WESTON CONSULTING

**RE: Site Design Response Letter
51 and 57 Tannery Street, 208 Emby Drive (OZ/OPA 18 12)
City of Mississauga**

Figure 1: Figure 11-1 – Restrictions on the Proximity of Intersections and Entranceways to Public

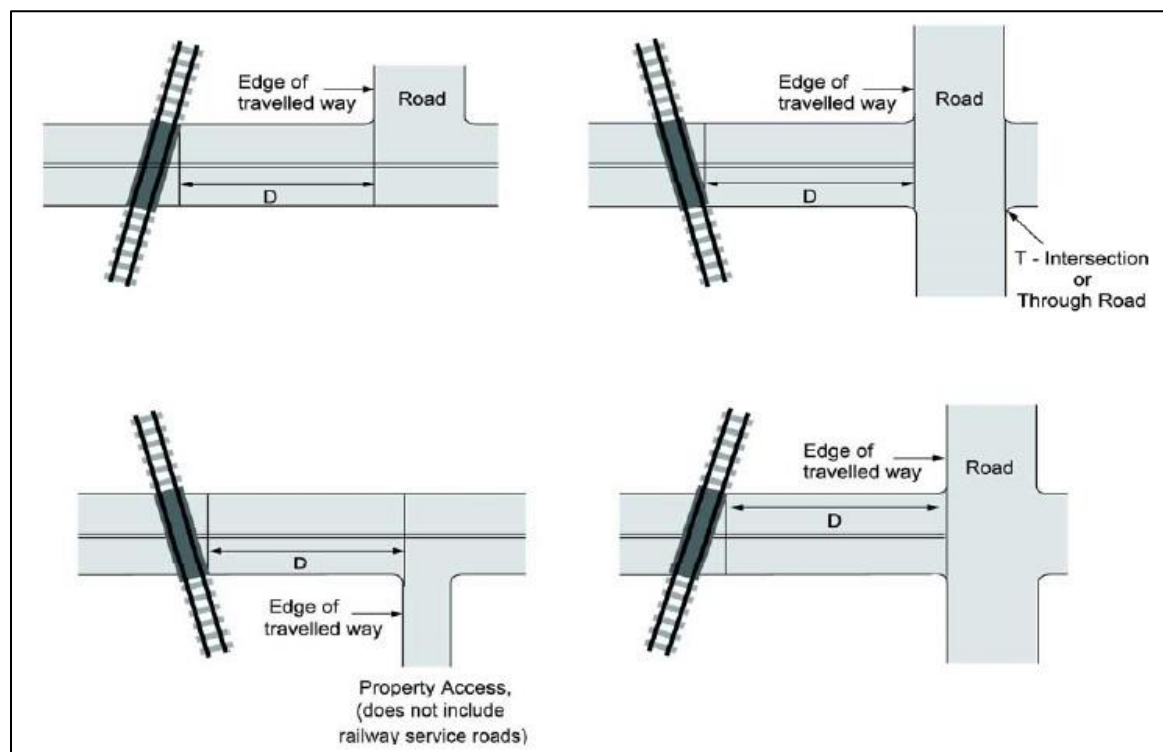
The future intersection with Tannery Street is proposed to be located approximately 35 metres east of Rutledge Road. Staff had previously requested that the proposed extension align with

Rutledge Road to create a single intersection to service developments on both sides of Tannery Street. The Traffic Impact Study prepared by LEA Consulting has confirmed that the proposed alignment is sufficient as it provides a 30 metre setback from nearest railway track, in accordance with the Transport Canada Grade Crossing standards. Additionally, the TIS, prepared by LEA Consulting notes that there is sufficient separating distance between the proposed alignment of Emby Drive and the existing Rutledge Road and Tannery Street intersection to provide appropriate sightlines for outbound left turn movements and to ensure that the inbound left turning movements do not overlap.

It is our opinion based on the applicable Transport Canada regulations and the Traffic Impact Study that the proposed road alignment is sufficient from a traffic circulation and road safety perspective. Further, the proposed alignment allows for the optimal development of the lands by providing one larger development parcel that can utilize greater development efficiencies, contribute to achieving the City's intensification policies, create a welcoming street frontage, provide additional landscaping and centralized amenity space in accordance with applicable design guidelines and development principles and achieve the densities envisioned by the Official Plan.

Figure 4: Examples of Terramesh Wall

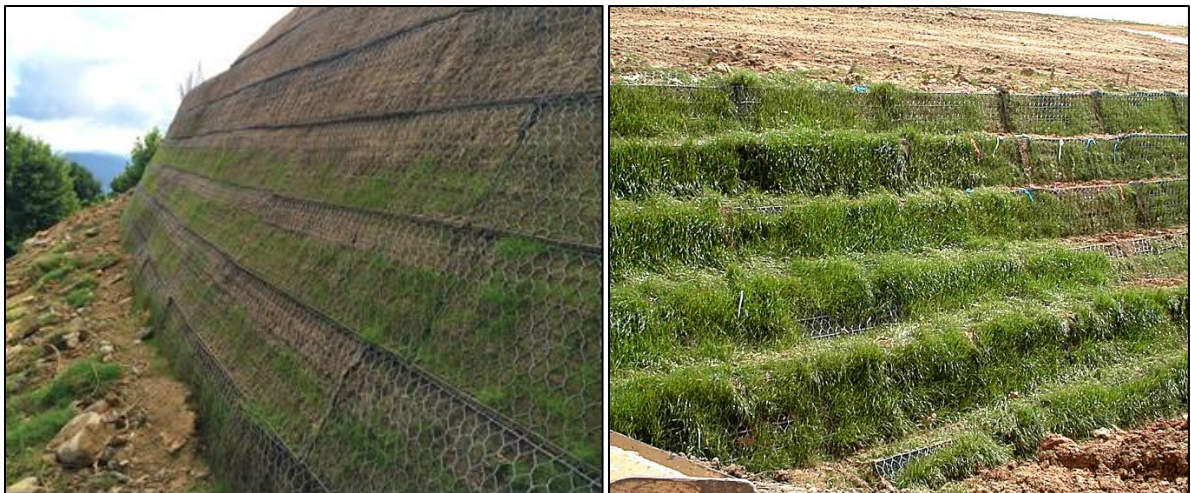
Due to the proximity of the aforementioned rail line to the subject lands, a noise attenuation/crash wall is required along the eastern boundary of the lands. The City of Mississauga has Design Reference Notes for “*Noise Attenuation Walls Along Rail Lines*” which are applicable in the context of the proposed development. The purpose of the guidelines is to minimize opportunities for graffiti that will damage the walls and create unsightly views abutting new residential developments. The following elements have been incorporated into the proposed noise attenuation wall as indicated in the Design Reference Notes:

- The acoustical portion of the wall that is not required to meet the crash wall specifications is located towards the northern end of the property closer to Tannery Street. This acoustical wall is proposed to be a “*Green Terramesh Wall*” as indicated on the submitted site plan. The terramesh wall consists of soil and grass plantings contained within a mesh wiring that affixes the vegetation to the wall. This type of feature enhances the aesthetic of the development and provides a more enhanced lanscape screening feature. The terramesh wall removes the potential for graffiti as is the purpose of the Design Reference Notes.

Figure 6: Site Circulation Plan

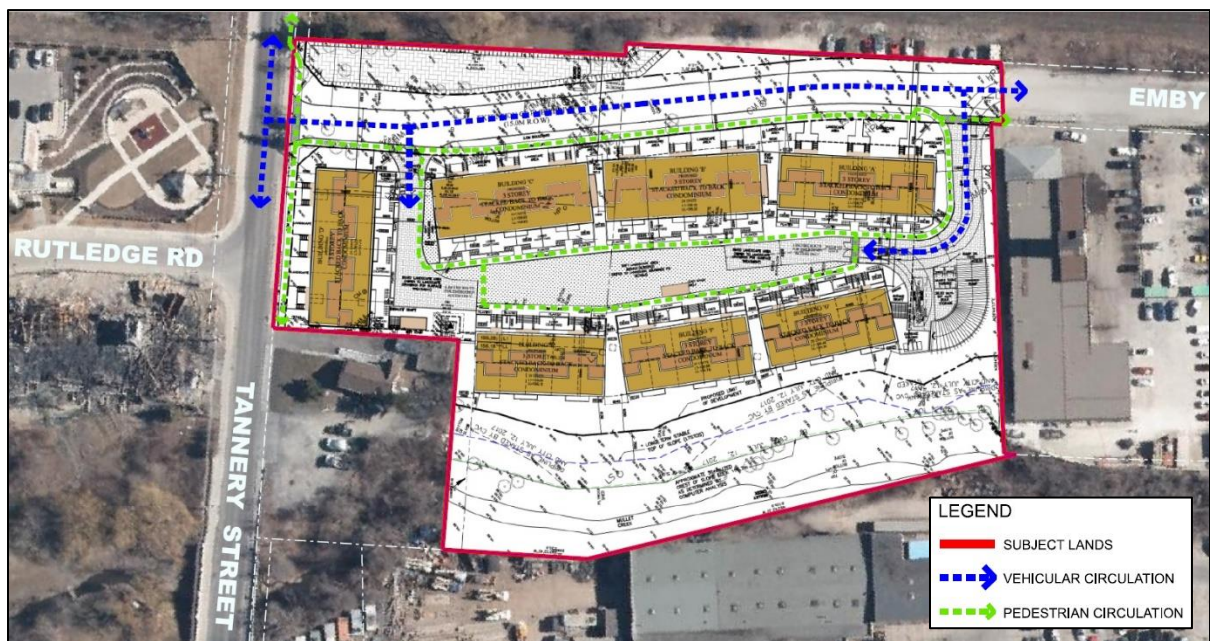
In response to staff comments, the following Circulation Plan has been prepared to demonstrate vehicular and pedestrian movements in and around the subject lands. The circulation strategy builds on the principle of creating a pedestrian oriented environment and prioritizing walkability over the use of auto vehicles. The vehicular access point provided from the extension of Emby Drive are localized with the intention of creating a pedestrian zone at the heart of the development. The access location at the southern end of the development will provide vehicular access for residents, visitors and servicing vehicles.

The loading area and waste collection area is conveniently located at the rear of the site behind proposed buildings, screened from the public realm. The loading area is designed to allow waste collection vehicles and other service vehicles maneuver and turn within the site. A 6m wide fire route extends from this area to allow fire trucks enter the premise when required. Appropriate curb radii and road widths are indicated in the Site Plan that are based on minimum standard requirements. An additional fire route access is provided towards the northern end of the development, also off of the Emby Drive extension. This access is for the fire route only and will be secured to prevent unauthorized access.

Pedestrian circulation routes have been considered given that the parking is located underground and direct access to each unit from the parking level is not provided. The (3) proposed exit stairs are indicated on the site plan and are located along pedestrian access routes, while being evenly distributed throughout the site providing ease of access to all residents. The development's central courtyard provides opportunities for pedestrian circulation around the development. The site can be accessed by pedestrians at either of the vehicular access points to provide connections with the surrounding neighbourhood and transit services to the south. Each building block is accessed with 1.8 m wide walkways, which is above AODA standards. The Circulation Plan is shown in Figure 6, while also attached to this letter.

Figure 7: Conceptual Tertiary Plan

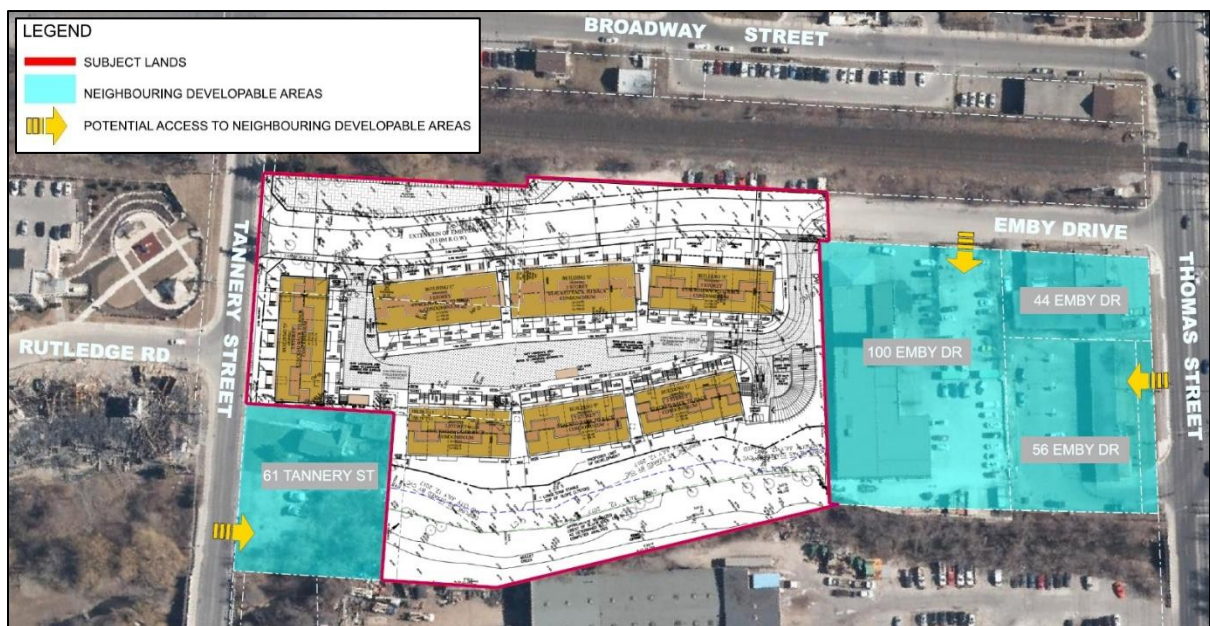
In response to staff comments, a conceptual tertiary plan has been prepared to illustrate the potential development options for adjacent properties. The plan considers current parcels located within the area bound by Tannery Street, the Mullet Creek, CP Rail right-of-way and Thomas Street. It provides details as to how 61 Tannery Street and 44, 56 and 100 Emby Drive may be

61 Tannery Street is located at the northwest corner of the site area. It has prominent frontage along Tannery Street and may be developed to include future residential uses. As shown on the tertiary plan, the property can obtain access from Tannery Street and develop as an independent parcel with transition to the Mullet Creek to the west.

The properties to the south of the subject lands are currently utilized as industrial operations and are designated for “*Residential High-Density*” uses in the Mississauga Official Plan, having an FSI range of 1.0 – 1.8. As shown on the tertiary plan, the consolidation or independent development of these lands can be accommodated based on the developable site area, frontages and access to public roadways. The site is suitable for higher density development given its location directly adjacent to the Streetsville GO Station. The Conceptual Tertiary Plan is shown in Figure 7, while also attached to this letter.
